**RESPONSE TO SUBMISSIONS (RTS)
Cobra Waste Solutions Resource Recovery Facility
30 Loftus Road, Yennora (SSD-9320662)**

Report No: 201156-03_RTS_Rev5
February 2023
(Released: 17 February 2023)

Figure 2-1: Site Water Balance

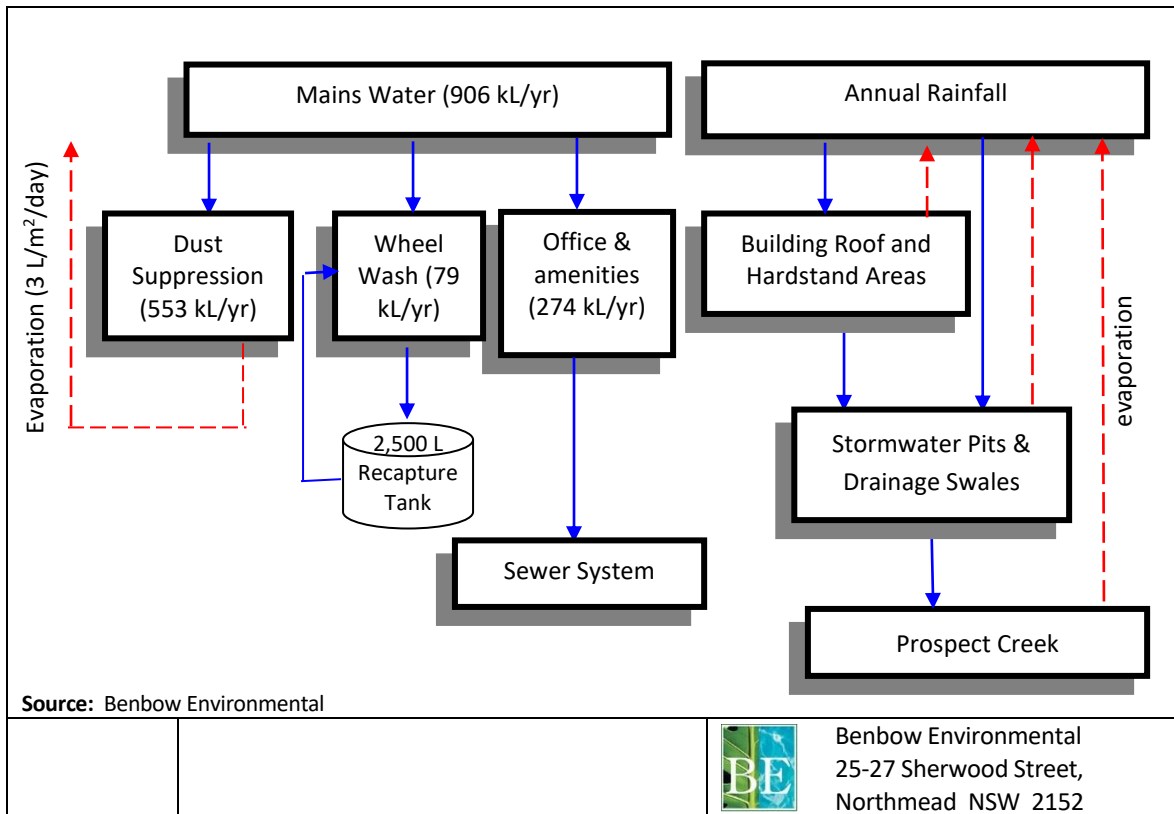
- *Provide a breakdown of water and wastewater usage details as requested by Sydney Water in their letter dated 19 July 2021 (EIS Attachment 2).*

Office use:	951 Litres per day (274 kL/yr)
Dust suppression:	1,920 Litres per day (553 kL/yr)
Truck wheel wash top up:	252 Litres per day (79 kL/yr)
TOTAL water requirement:	3,123 Litres per day (906 kL/yr)

Figure 2-1 displays a simple site water balance for the development.

Figure 2-3: Subject site within Area 3 North of the old Alcoa site

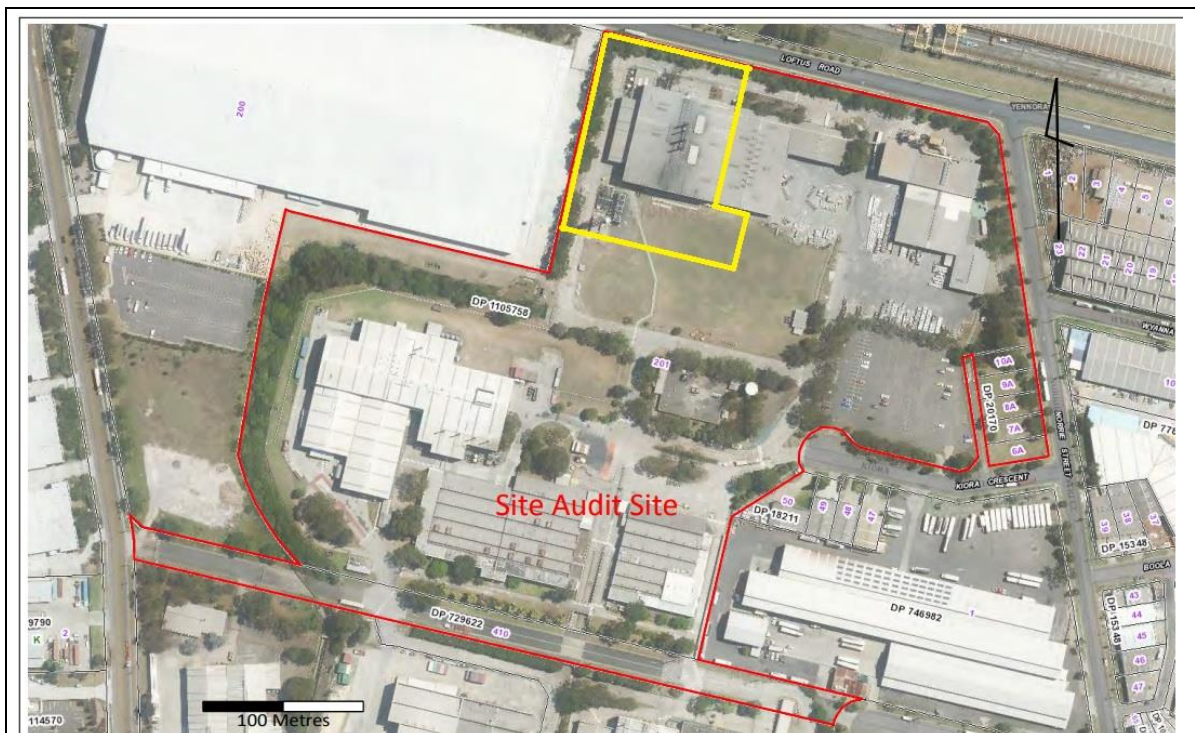
- *Provide the Remedial Action Plan and Site Audit Statement and Report for the site or former Alcoa site detailing the site is suitable for industrial use and any ongoing management measures or any insitu contamination.*

The Site Audit Report undertaken by Enviroview Pty Ltd in 2016 is provided as Attachment 9 of this RtS. The Remedial Action Plan (RAP) referenced below was prepared by ERM and is discussed in Section 8 of the Site Audit Report. A copy of the RAP was not able to be obtained.

The subject site formed part of the ingot area and is located in the “Area 3 North” of the old Alcoa site which is a small 0.4 hectare area within the 13.3 hectares of Area 3 North. It is noted that the Site Audit Report relates to Area 3 North. This is shown on the following figure.
